Access Compliance Report Public Rights-of-Way (Curb Ramps)

Intersection ID: 14251 Main Street: CHESTERFIELD AV **Cross Street: LORNA_ST** Location: W ADA ID: A2F0D0DC99C8 Ramp Type: Perp Initial Pass/Fail: Fail **Overall Compliance: No Severity Score:** 25

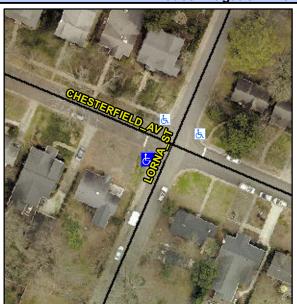
CHESTERFIELD AV Street 1 Name Stop Condition-Street 2 StopSign Street 2 Name N/A Stop Condition-Street 1 N/A Possible Solutions: Remove & Replace Entire Ramp. Surveyor Notes: N/A PROW/ADA: Not Found, R304.5.3

Field Measurements/Component Compliance					
Compliance Description		Data	Comp	oliance Description	Data
N/A	Ramp Length (in)	60.0	Yes	Ramp Slope (%)	5.9
Yes	Ramp Width (in)	100.0	No	Ramp XSlope (%)	7.3
N/A	Flare Type LT	N/A	N/A	Flare Type RT	N/A
N/A	Flare Slope LT (%)	N/A	N/A	Flare Slope RT (%)	N/A
N/A	Flare Traversable LT?	N/A	N/A	Flare Traversable RT?	N/A
N/A	Landing Length (in)	N/A	N/A	DWS Provided?	N/A
N/A	Landing Width (in)	N/A	N/A	DWS Contrast?	N/A
N/A	Landing Slope (%)	N/A	N/A	DWS Length (in)	N/A
N/A	Landing X Slope (%)	N/A	N/A	DWS Full Width?	N/A
N/A	Landing Curb? (Y/N)	N/A	N/A	DWS Offset (in)	N/A
N/A	Shared Landing?	N/A			
N/A	Gutter Ponding?	N/A	N/A	Gutter Slope (%)	N/A
N/A	Gutter Lip Ht (in)	N/A	N/A	Gutter X Slope (%)	N/A
N/A	Painted X Walk1?	No	N/A	Painted X Walk2?	N/A
	X Walk 1 Direction	To NE		X Walk 2 Direction	N/A
N/A	X Walk 1 Width (in)	N/A	N/A	X Walk 2 Width (in)	N/A
	X Walk 1 Slope (%)	4.0		X Walk 2 Slope (%)	N/A
